West Herr Lincoln
2601 Millersport Highway
Amherst, NY

Addendum 2
May 03, 2021
Page 1 of 8

A1 WALL SECTION @ RUNWAY (THROUGH WOOD SOFFIT)
 SCALE: 3/4" = 1'-0"

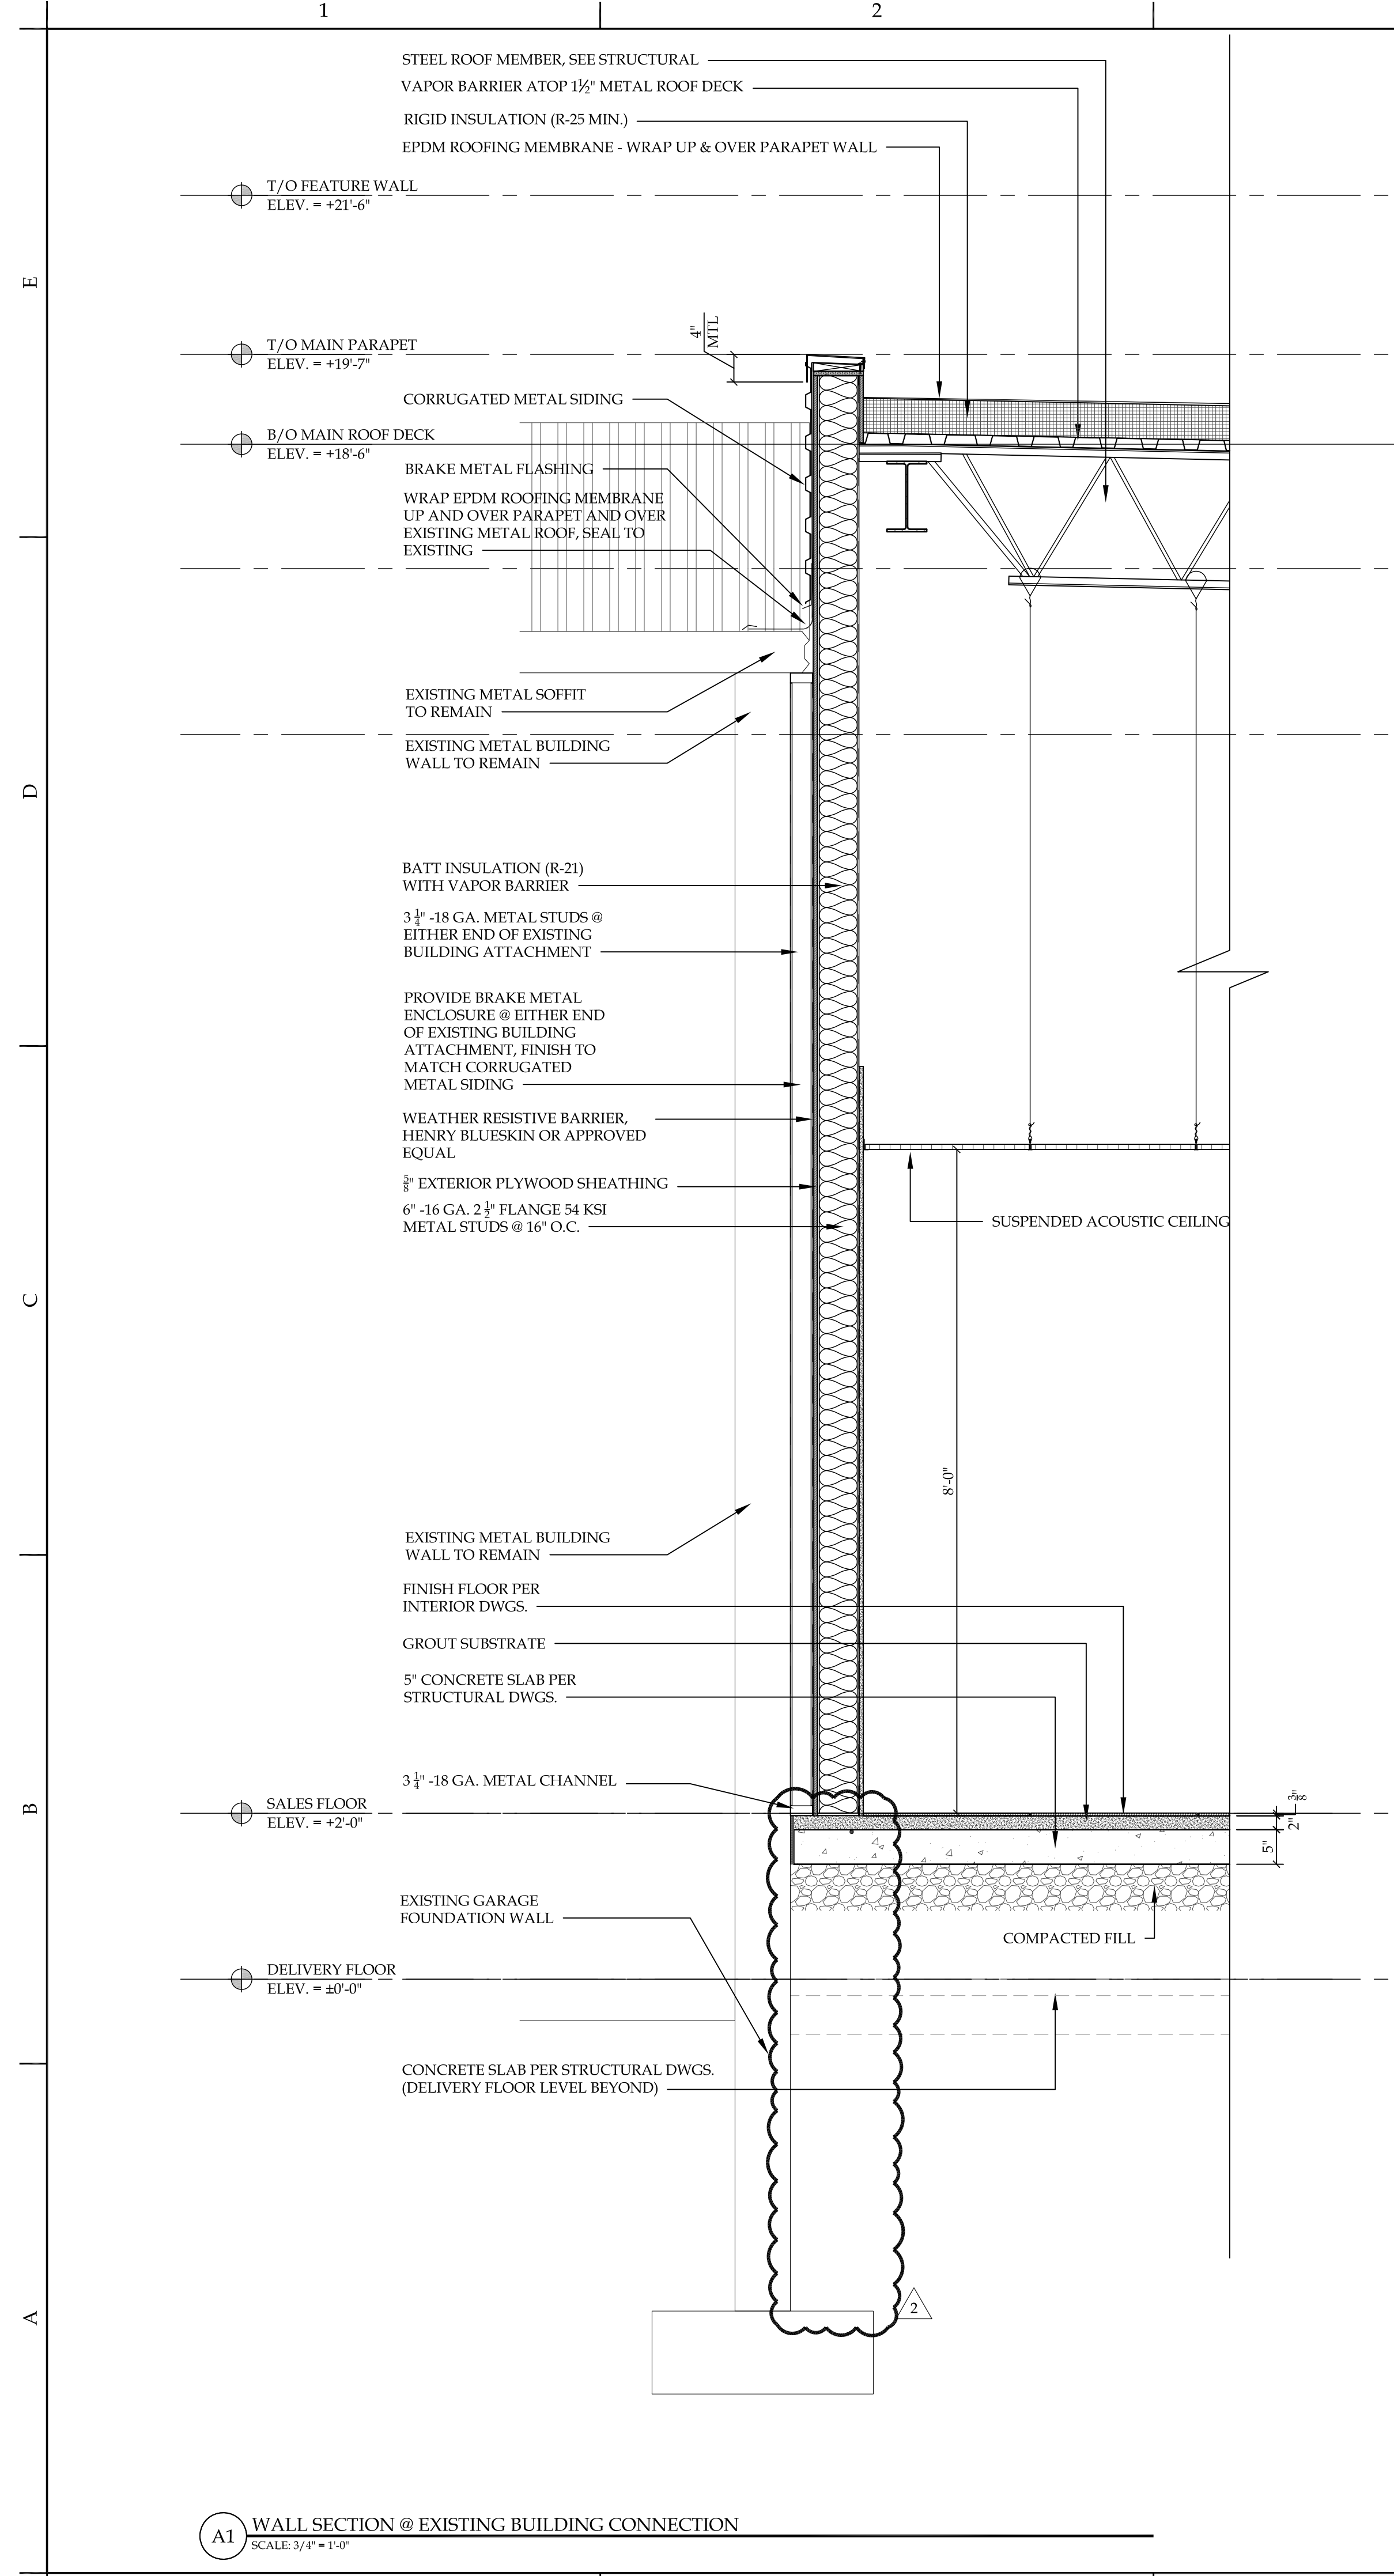
5. Reference RCP on drawing A-103 - Acoustical ceiling and a suspended gyp. ceiling is shown in the vehicle display area. Sections A1/A301 and A1/A302 show a drywall ceiling in these areas only, and does not detail soffits otherwise. Please clarify.

Answer: Ceilings should be as shown on the RCP A-103. See revised details A1/A301 and A1/A302 updated to correspond.

A1 WALL SECTION @ EXISTING BUILDING CONNECTION
 SCALE: 3/4" = 1'-0"

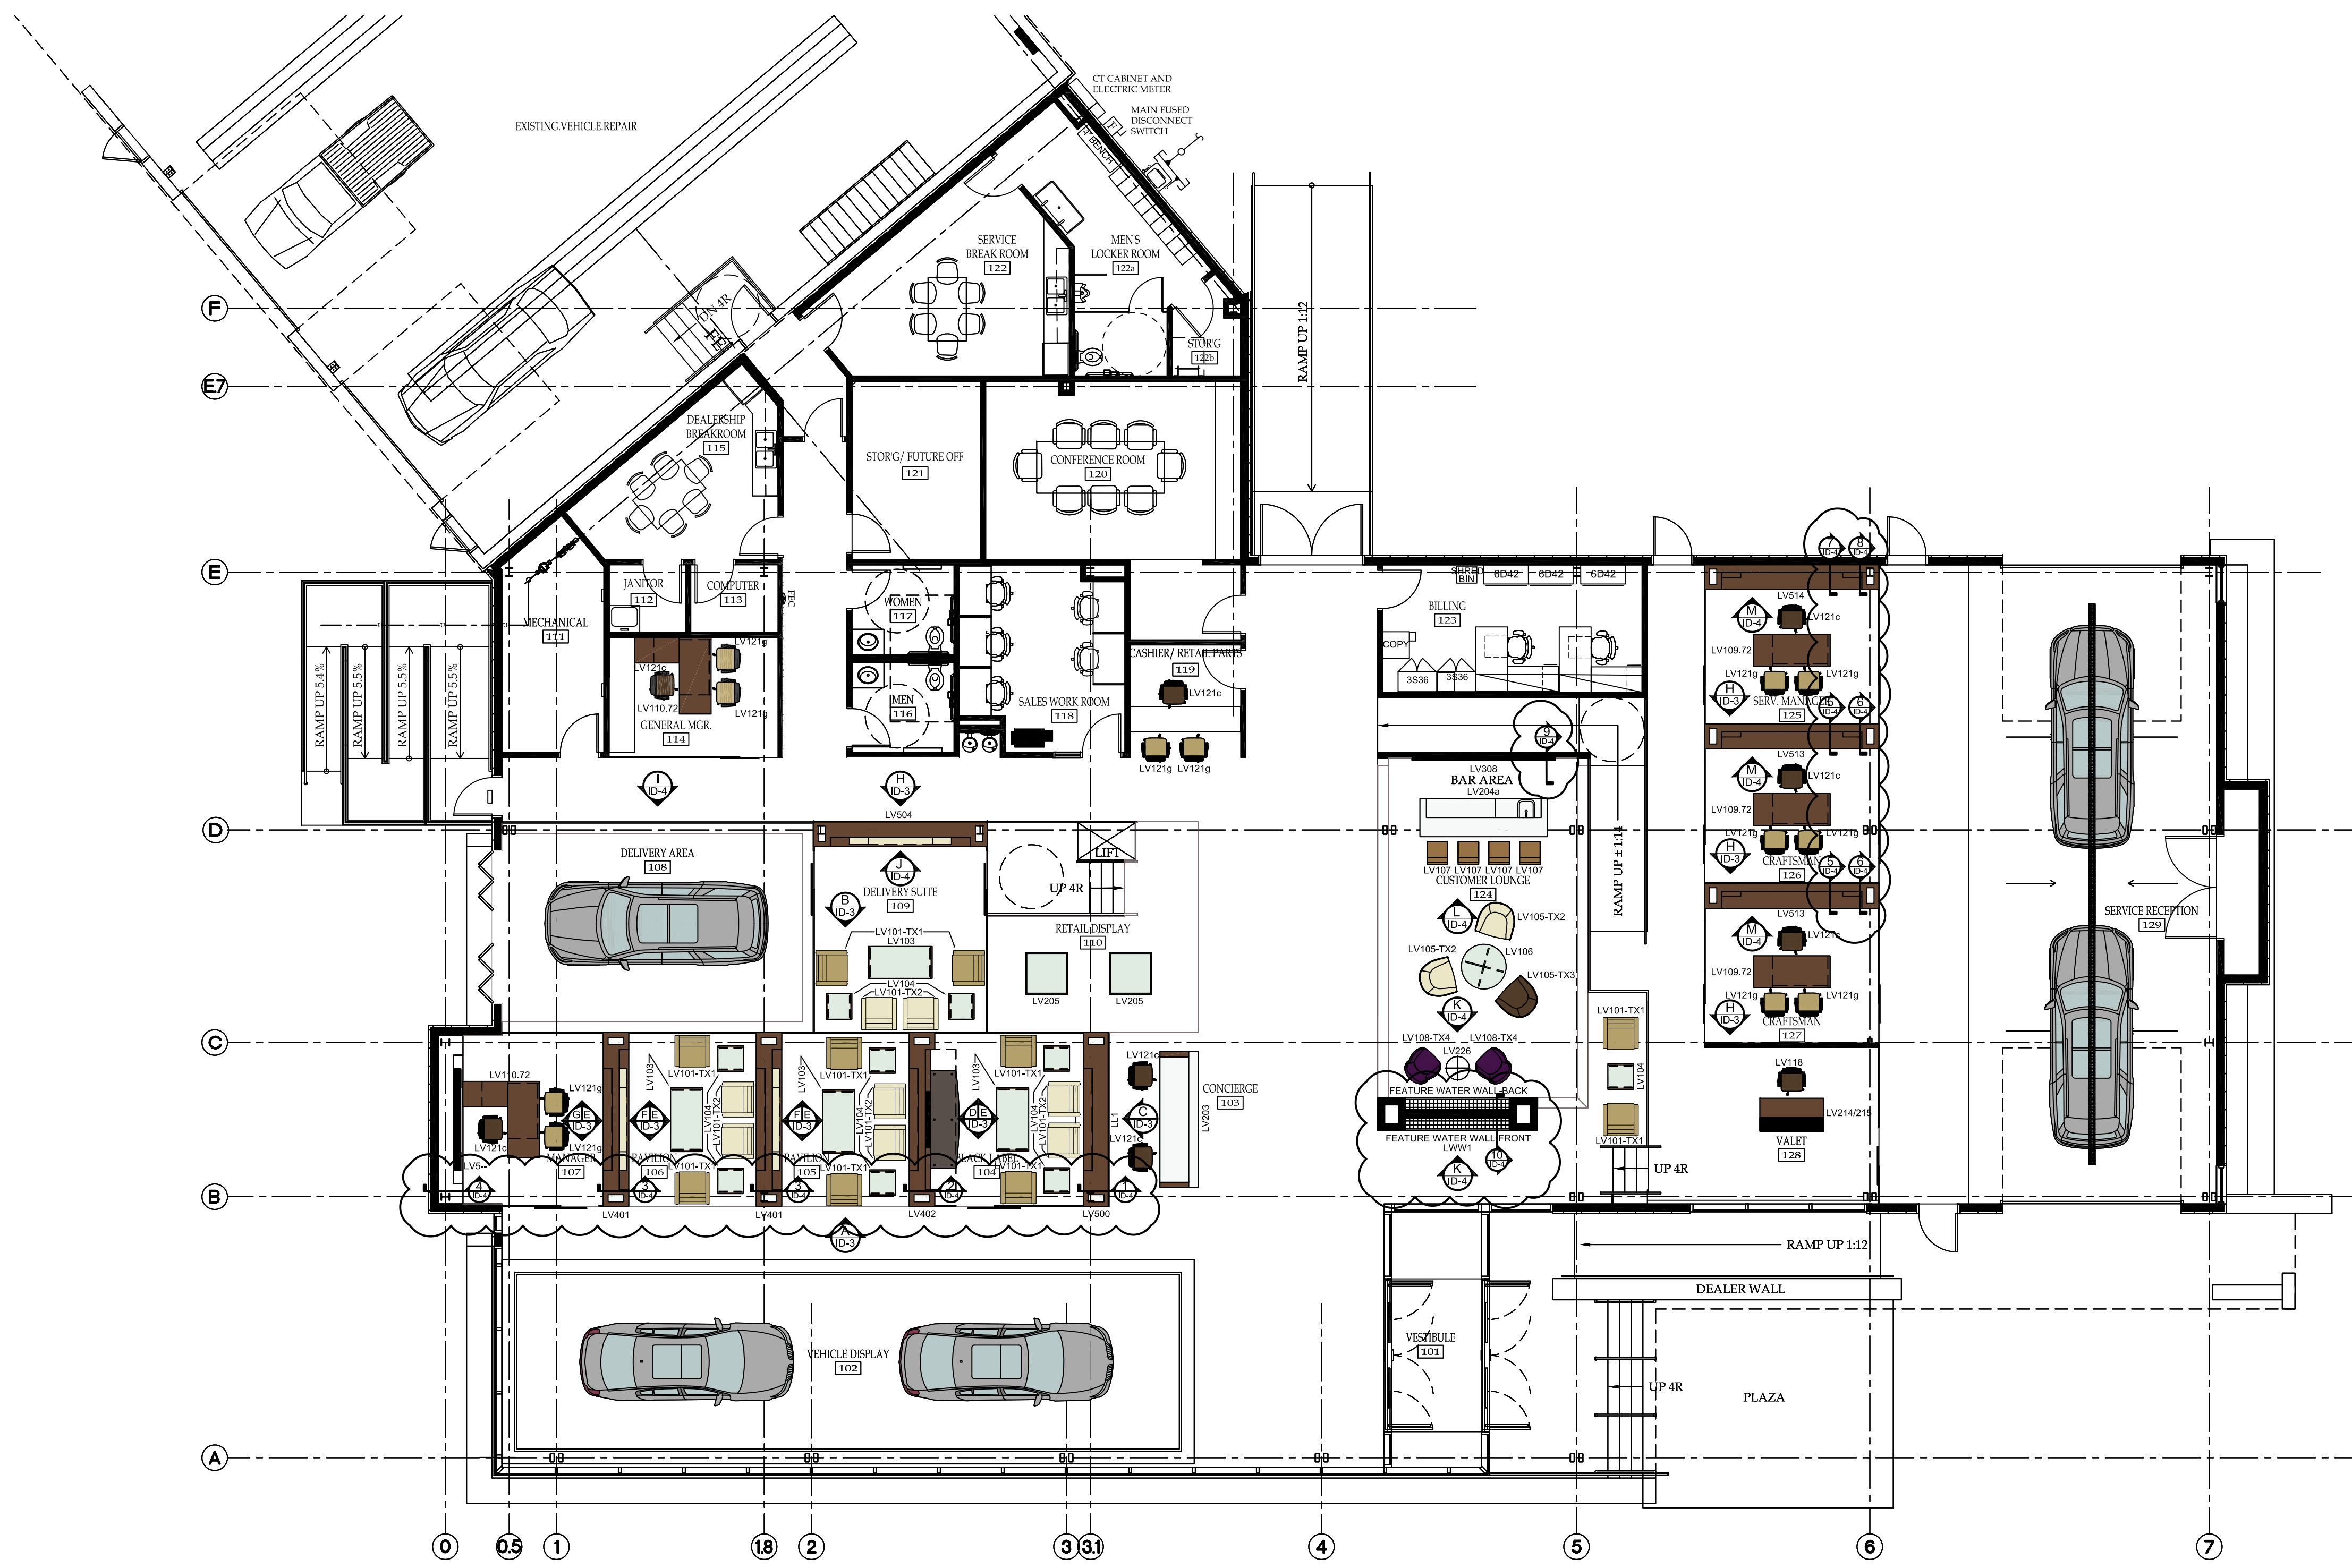
8. Reference A1/A306 – Section shows new wall being built in close proximity to existing wall with exterior plywood sheathing and weather barrier. This will be extremely difficult to build as drawn. Can the plywood sheathing and weather barrier be eliminated below the roof line of the existing building?

9. Wall section ‘A1/A-306’ is a cut thru the new addition connection at the existing building. I do not see a corresponding structural section thru this area. Is there a new foundation wall to be installed like the architectural shows? Structural drawings do not show this.

Answer: The plywood sheathing and weather barrier are required to ensure a water tight enclosure, as our building is abutting an existing pre-engineered metal building with a projecting soffit.

Answer: A foundation wall is not required. It has been removed from the architectural drawing-see revised A1/A-306.
